SB CG 601-1014 P1, Rev. 2

# SERVICE BULLETIN

**Subject:** Turbocharger hose replacement

**Type affected:** (Reims) Cessna (F) 172 with TAE 125-02-99 & -114

Figure 1: turbocharger hose, installed

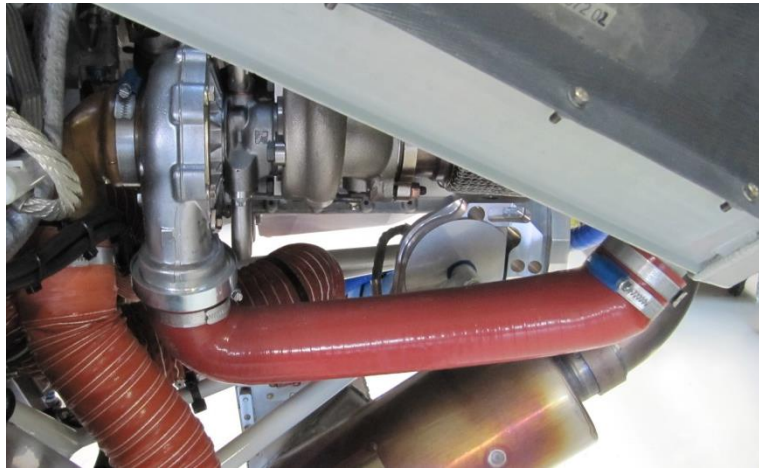
**Remarks:** Only the hoses of the manufacturer "BOOST products" with batch no. 3101-001 are affected. These hoses are not pressure stable and must be replaced.

- Inspect the installed turbocharger hose and verify the part number TAE EPA 40-7520-H0131 01. Refer to figures below.
- If the installed hose is labelled with “BOOST products” and batch number “3101-001” the hose is critical and must be replaced. All hoses with deviating batch no. or other manufacturer label are uncritical.

- Install a factory new turbocharger hose P/N 40-7520-H0131 01 using three new hose clamps NM-0000-00170 01. Shorten the hose if needed.

Secure the hose with one clamp on turbocharger side and two clamps on intercooler side.
